Beaver Valley Power Station, Unit Nos. 1 and 2
Docket No. 50-334, License No. DPR-66
Docket No. 50-412, License No. NPF-73
Davis-Besse Nuclear Power Station
Docket No. 50-346, License No. NPF-3
Perry Nuclear Power Plant
Docket No. 50-440, License No. NPF-58
FirstEnergy Nuclear Operating Company's (FENOC's) Second Six-Month Status Report
in Response to March 12, 2012 Commission Order Modifying Licenses with Regard to
Reliable Spent Fuel Pool Instrumentation (Order Number EA-12-051)
(TAC Nos. MF0799, MF0800, MF0960, and MF0802)

Beaver Valley Power Station Second Six-Month Status Report for the Implementation of
Order EA-12-051, Order Modifying Licenses with Regard to
Reliable Spent Fuel Pool Instrumentation
Page 1 of 7

Response to Request for Additional Information for
Beaver Valley Power Station
Page 1 of 13

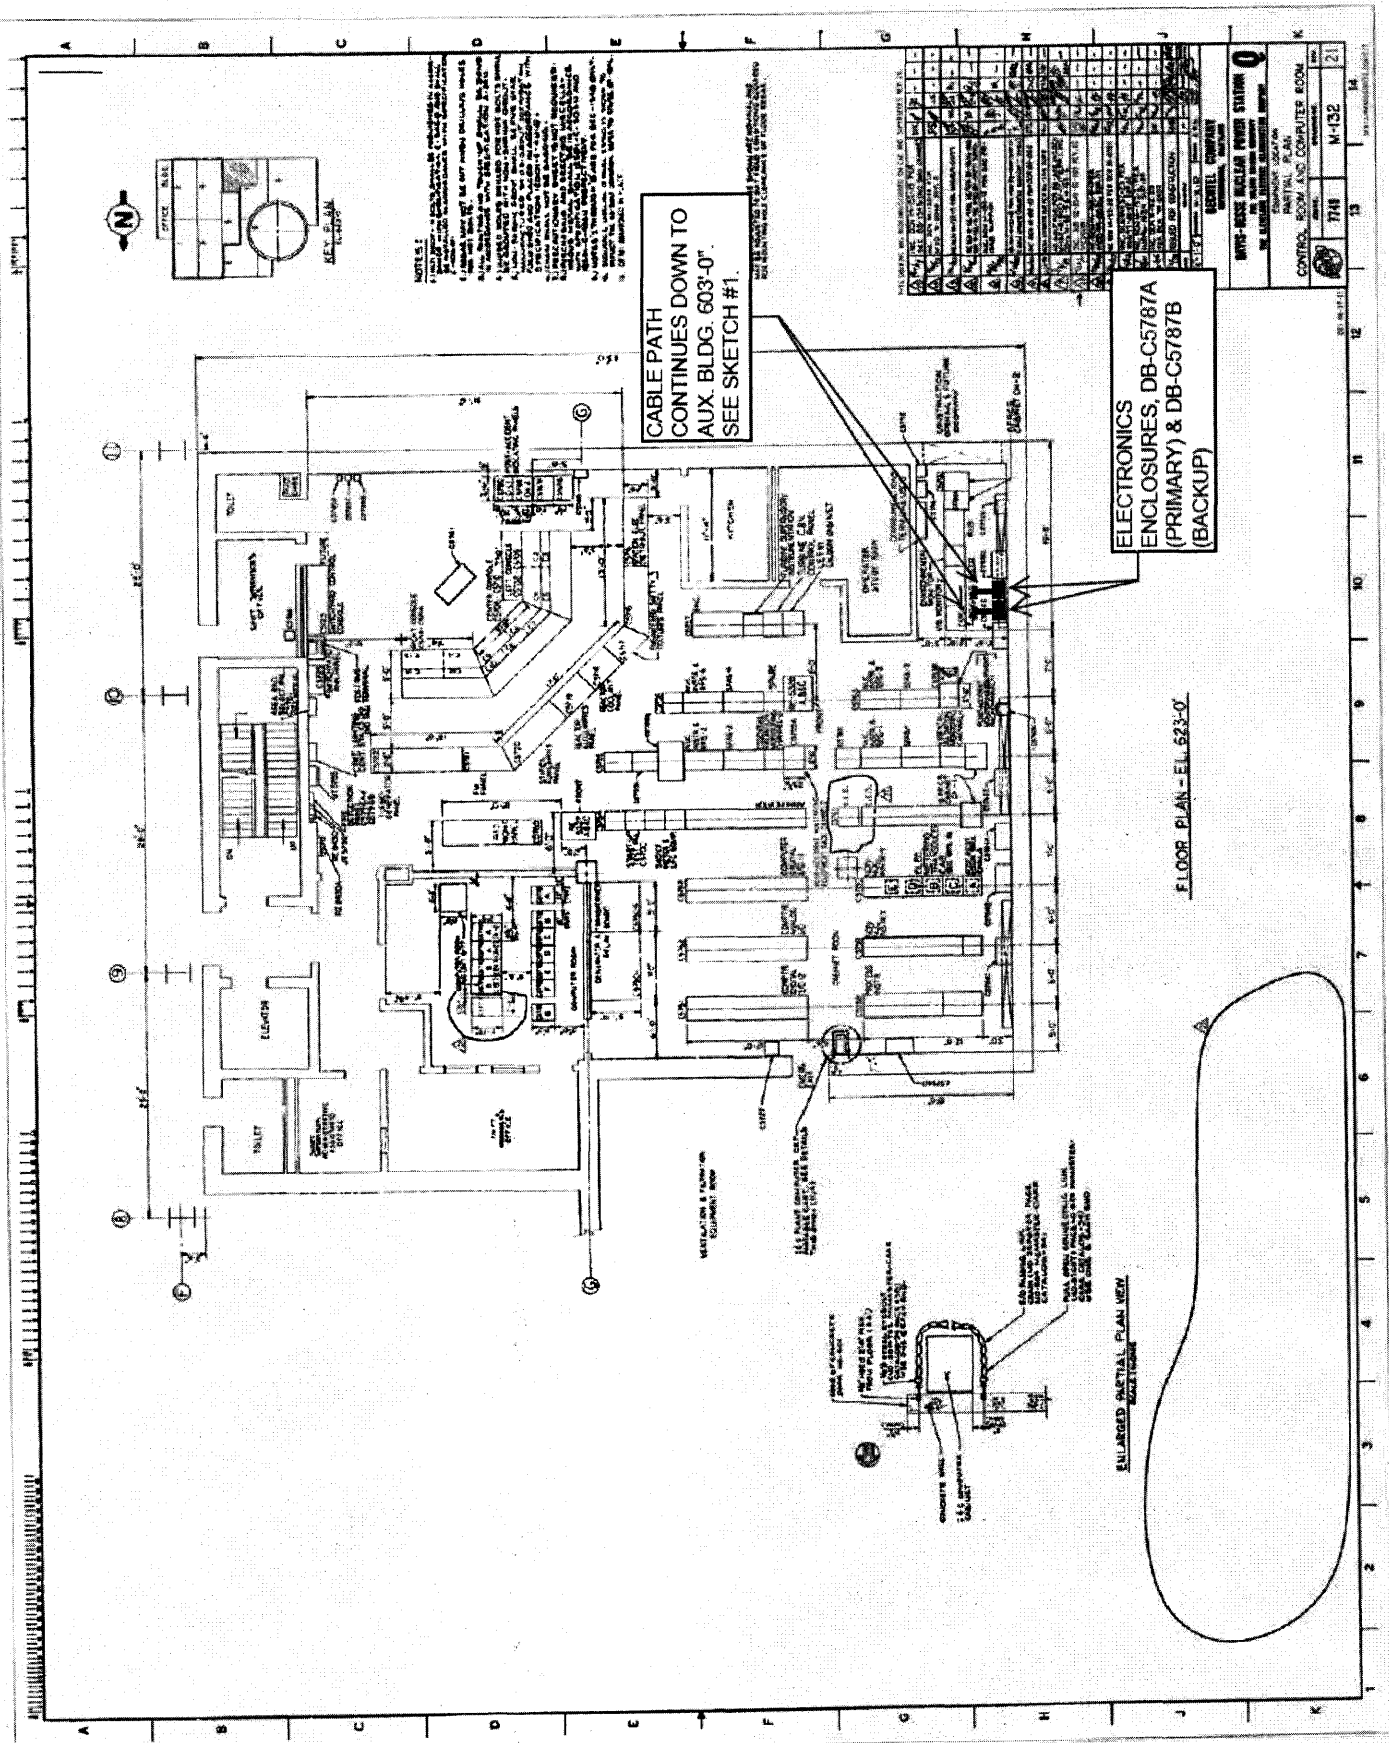
Please provide a clearly labeled sketch or marked-up plant drawing of the plan view of the SFP area, depicting the SFP inside dimensions, the planned locations/placement of the primary and back-up SFP level sensor, and the proposed routing of the cables that will extend from these sensors toward the location of the read-out/display device.

Below are excerpts from plant drawings, being used as sketches, that depict the preliminary design and locations of the two permanently mounted level probes within the SFP area and the cable routing to locate the electronics to a non-harsh environment outside the SFP area. These sketches are excerpts from the 30 percent design change package and include references to other sketches that are not included for this response.

The level transmitter electronics will be located in the auxiliary building EI. 603', on the same level as the SFP but in the building adjacent to the fuel handling building. The level transmitters located in the auxiliary building have a local display, although the credited display units will be located in the main control room.

The inner dimensions of the SFP are 52' 11.5" x 19' 11.5".

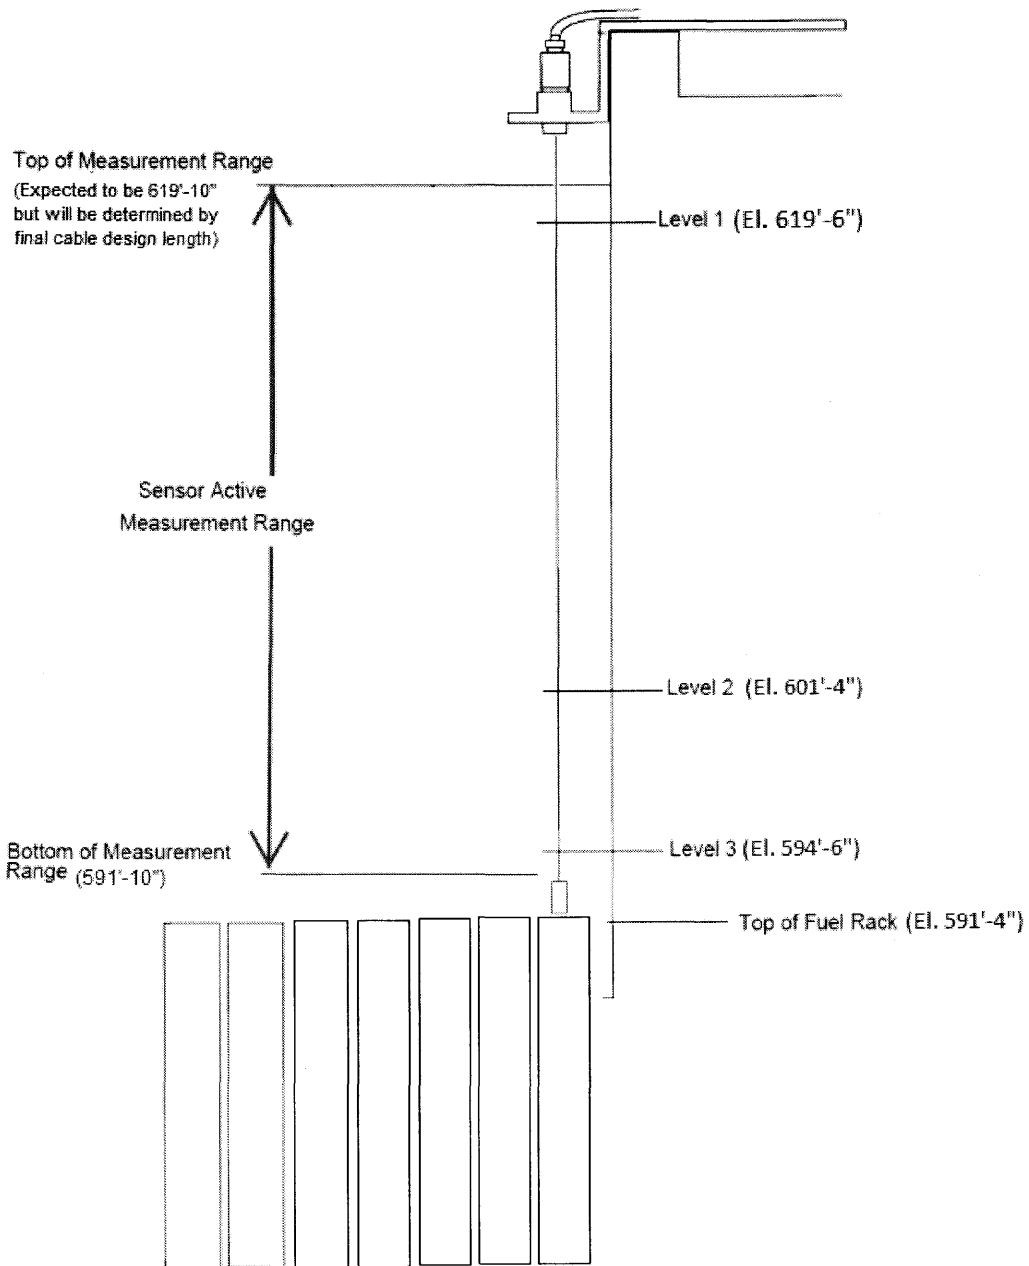
Please provide a clearly labeled sketch depicting the elevation view of the proposed typical mounting arrangement for the portions of the instrument channel consisting of permanent measurement channel equipment (e.g., fixed level sensors and/or stilling wells, and mounting brackets). Indicate on this sketch the datum values representing Level 1, Level 2, and Level 3, as well as the top of the fuel racks. Indicate on this sketch the portion of the level sensor measurement range that is sensitive to measurement of the fuel pool level, with respect to the Level 1, Level 2, and Level 3, datum points.

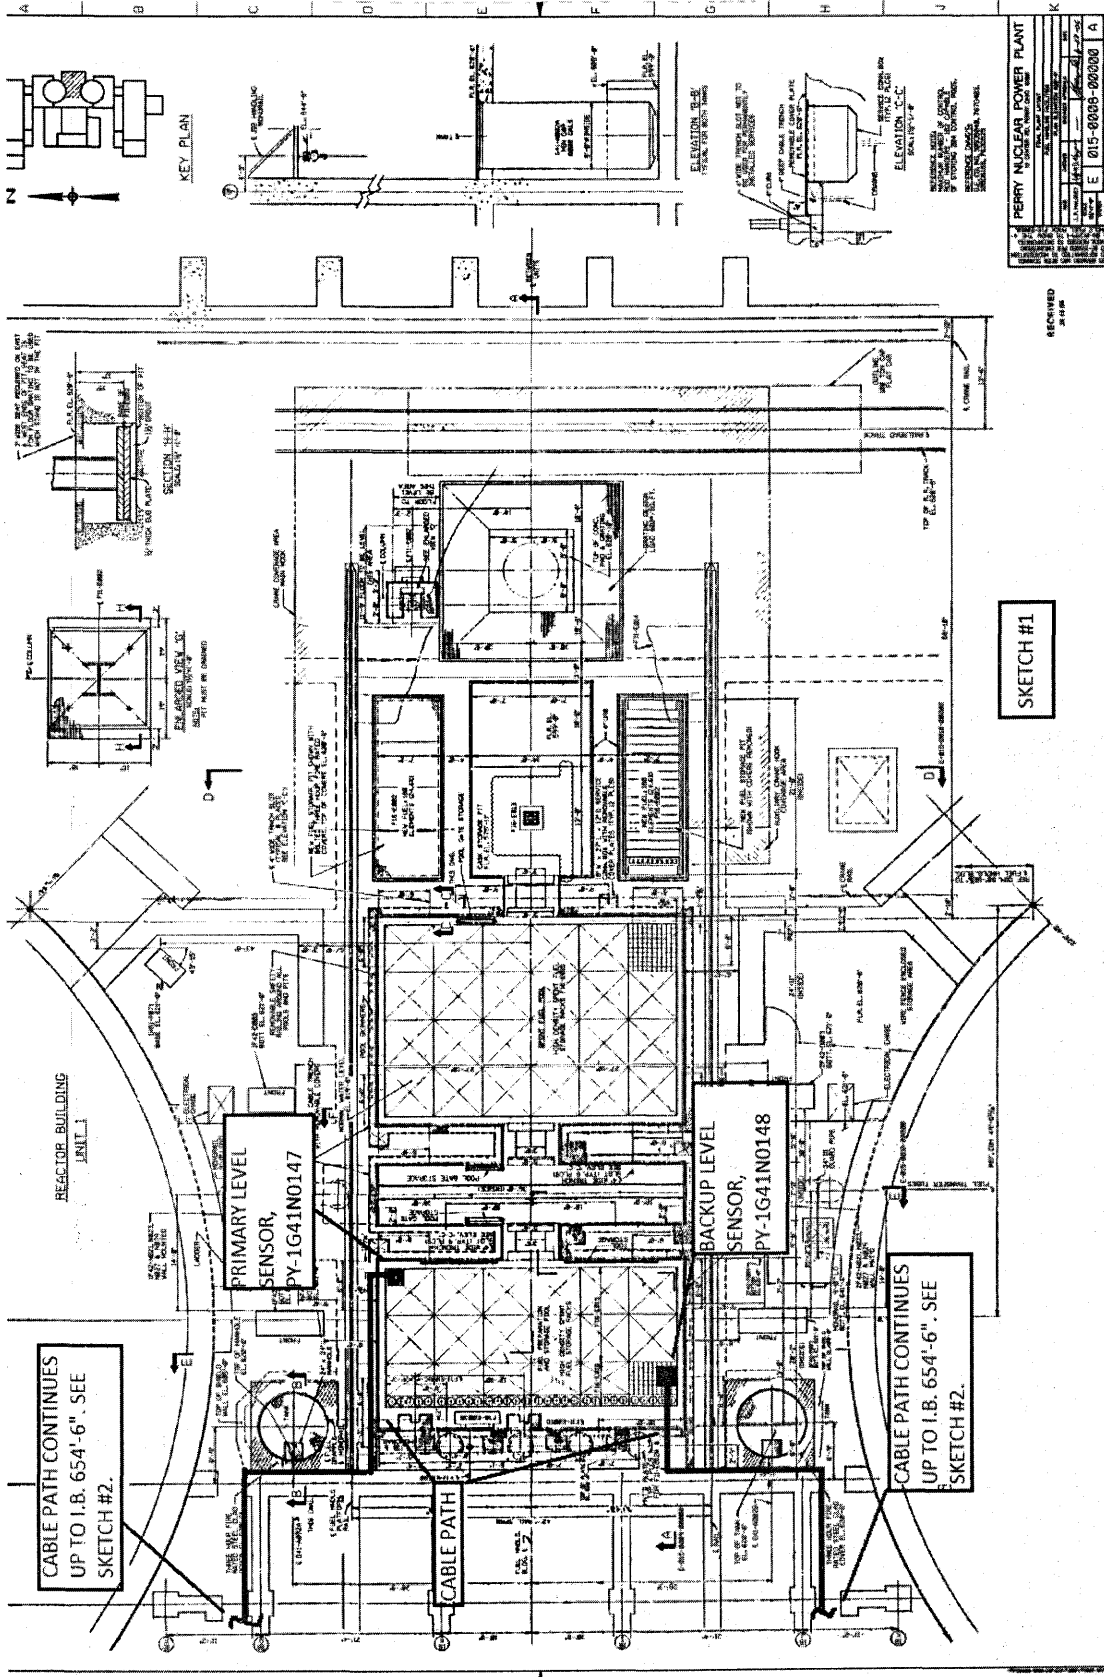
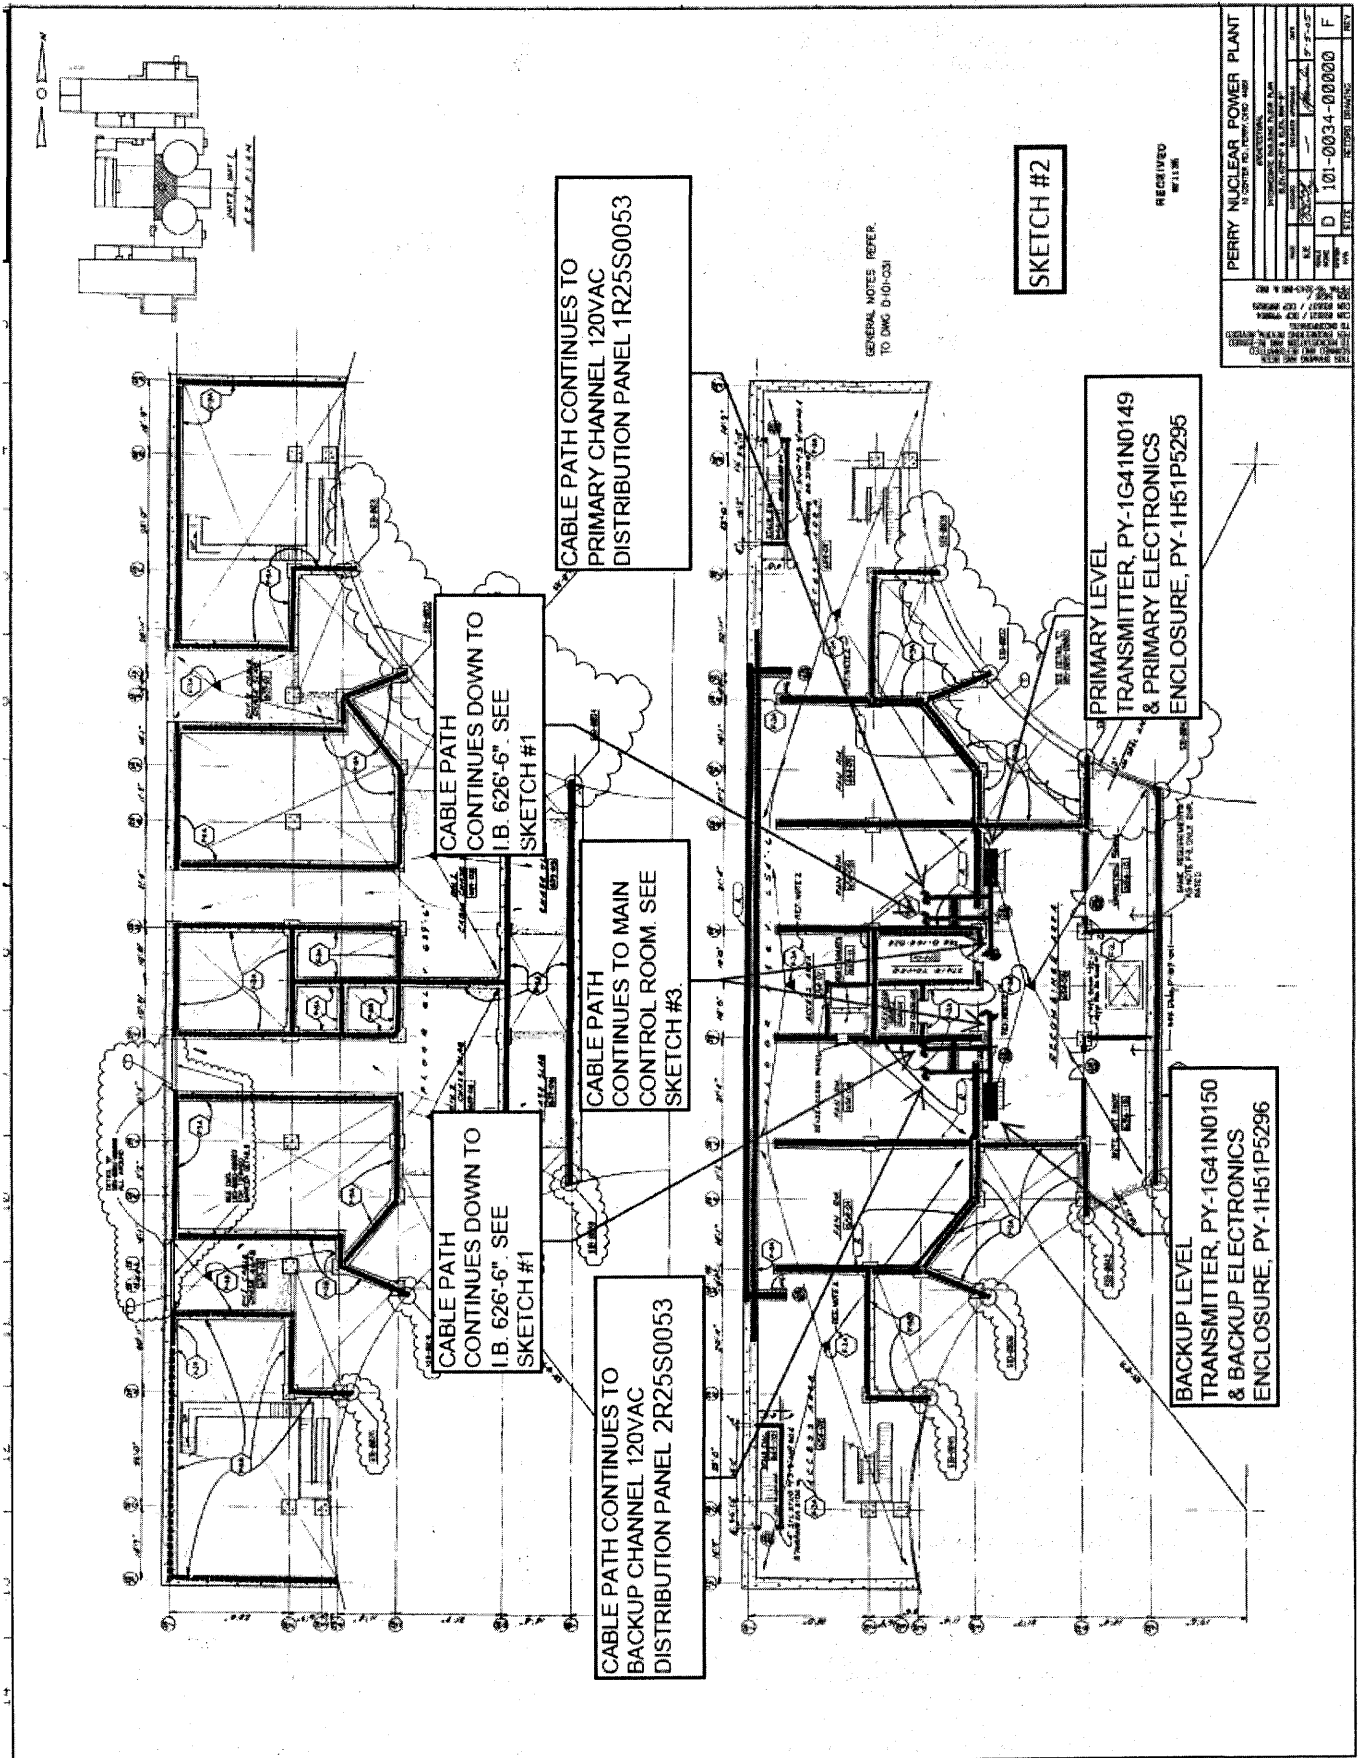
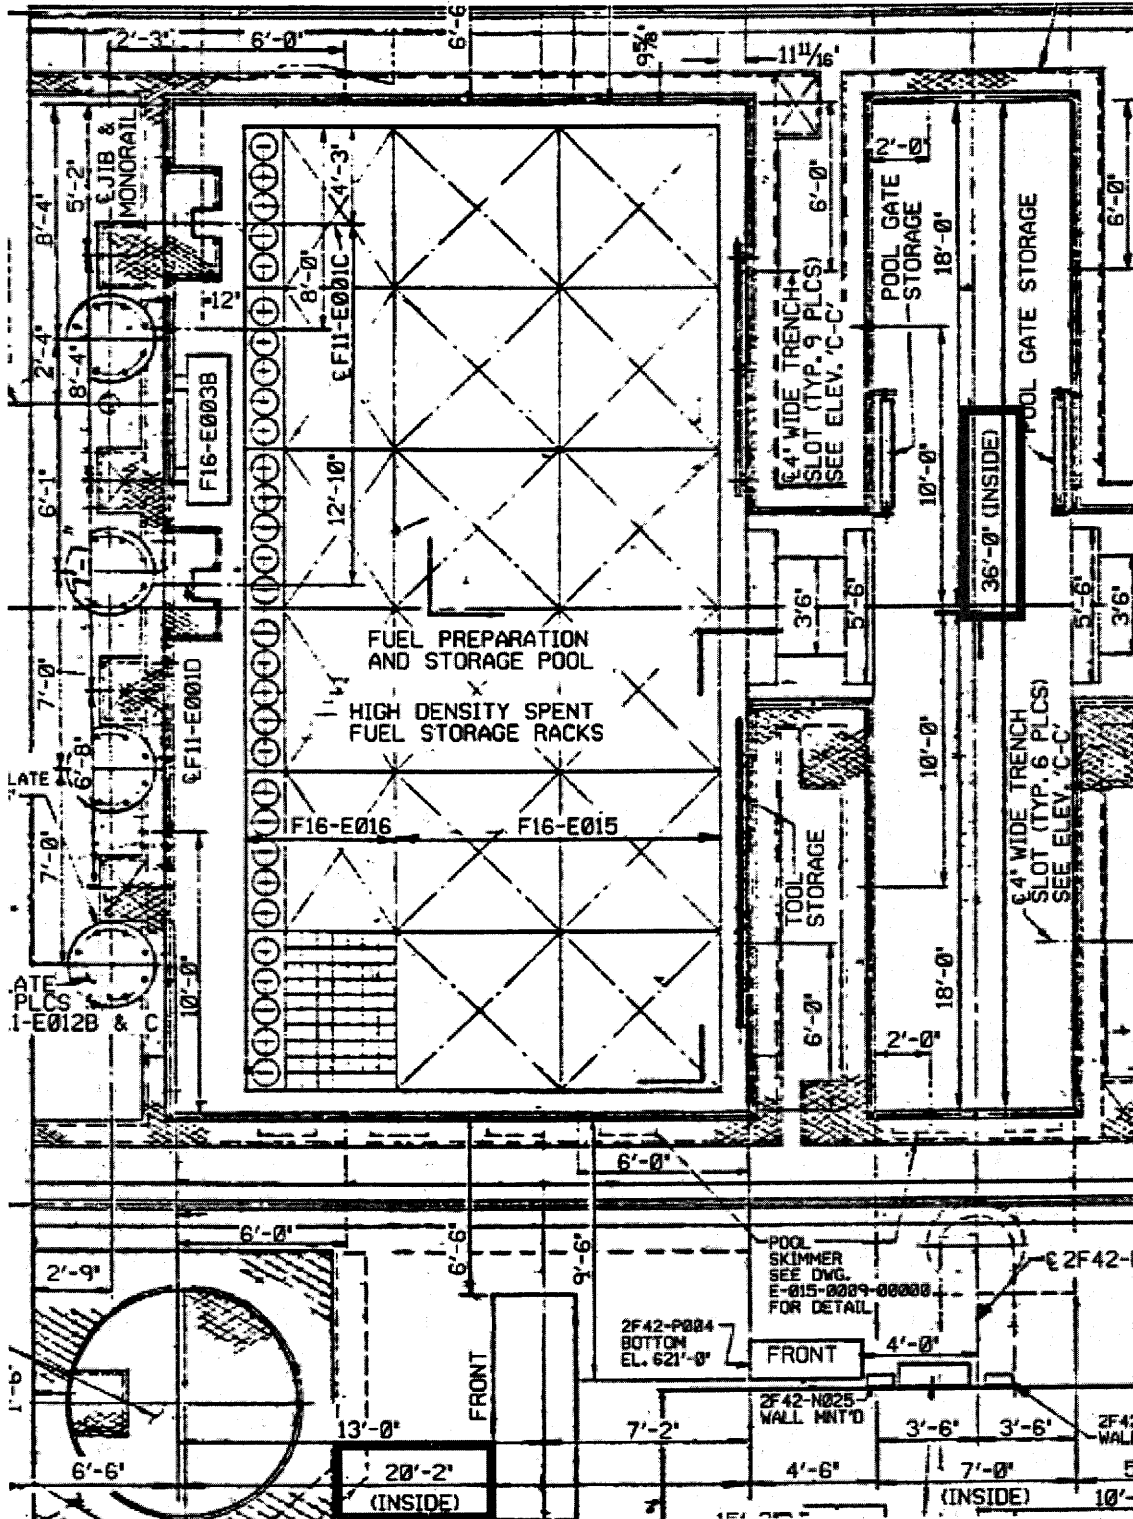
Please provide a clearly labeled sketch or marked-up plant drawing of the plan view of the SFP area, depicting the SFP inside dimensions, the planned locations/placement of the primary and back-up SFP level sensor, and the proposed routing of the cables that will extend from these sensors toward the location of the read-out/display device.

Below are excerpts from plant drawings, being used as sketches, that depict the preliminary design and locations of the two permanently mounted level probes within the SFP area and the cable routing to locate the electronics to a non-harsh environment outside the SFP area.

The level transmitter electronics will be located in the intermediate building elevation (El.) 654' 6", which is separated from the SFP area by one floor. The level transmitters located in the intermediate building have a local display, although the credited display units will be located in the main control room on the east wall, in panel 1H13P0970.

The inside dimensions of the fuel preparation pool, which is where the sensors will be installed, are 20' 2" x 36' 0". Reference the excerpt from a plant drawing below.
